Addendum 3

External works

PROJECT
SOUTHWEST WILDLIFE HOSPITAL
ADDRESS
48 MACDONALD STREET WARRNAMBOOL. VIC 3280

Project
**SOUTHWEST WILDLIFE HOSPITAL
48 MACDONALD STREET
WARRNAMBOOL**

DRAWING TITLE	METAL WORK_OUTDOOR CAGE
STATUS	FOR TENDER REVIEW

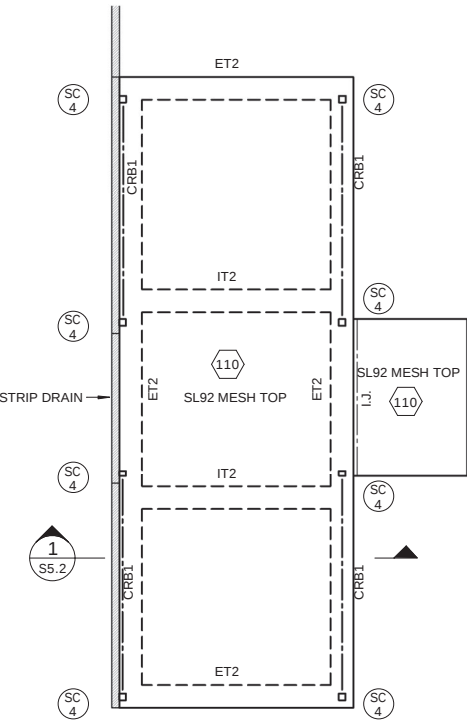
Rehabilitation outdoor holding areas, designed for multi-species use with consideration for ventilation, shade, misters, drainage, and species-safe containment.

The following auxiliary assets are to be separately itemised within the tender submission. Inclusion of these items in the final scope of works will be subject to Principal approval and available funding.

Items optional for quoting - Auxiliary Assets (Budget-Dependent Delivery)		
Ref	Item	Drawing No.
1	T05 CYCLONE FENCE	A1.1
2	ST06 COLORBOND FENCE WITH PRIVACY EXTENSION	A1.1
3	Rehabilitation outdoor holding areas (As below)	This Addendum
4	Outdoor enclosure pathways FFO7	A1.5.1
5	Sewer connection	Not designed
6	Bollard Lighting - 10W, 760lm, LED BOLLARD. IP65, IK08, 4000°K. BLACK FINISH.	E050
